CHANGE SHEET No. 67

AFFECTED DRG. NO.
ADRDE/1106-A4 (c)

NEW DRG. NO.
ADRDE/1106-A4(d)

PACK COVER (RUBBER BAND)
BRAKE PARACHUTE FOR MIRAGE-2000 AIRCRAFT

DRG No	DET. No 7
ADRDE/1106-A4 (a)(c)	22-SHTS
PART No.	SHT No. 22
D.S. CAT No	
AHSP

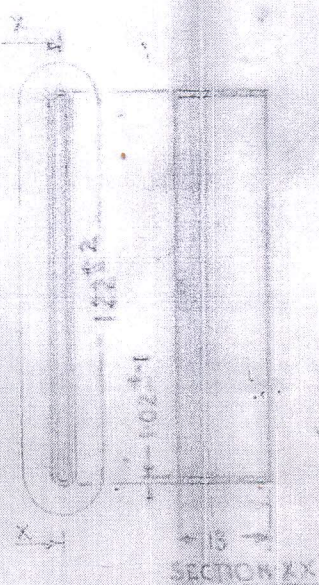
SL. No.	SHEET NO. & LOCATION	EXISTING	AMENDED	REASON
1.	SHEET No. 22 D2	MATERIAL: NATURAL RUBBER	MATERIAL: NATURAL RUBBER / HYPALON RUBBER	
2.	C2	BREAKING LOAD : 27 KG	BREAKING LOAD : 27 KG (MIN)	TOLERANCE SPECIFIED
3.	-do-	PERCENTAGE ELONGATION AT BREAK : 575%	PERCENTAGE ELONGATION AT BREAK : 500 % (MIN)	-do-
4.	-do-	SPECIFIC GRAVITY: 0.957	DELETED	NOT REQUIRED
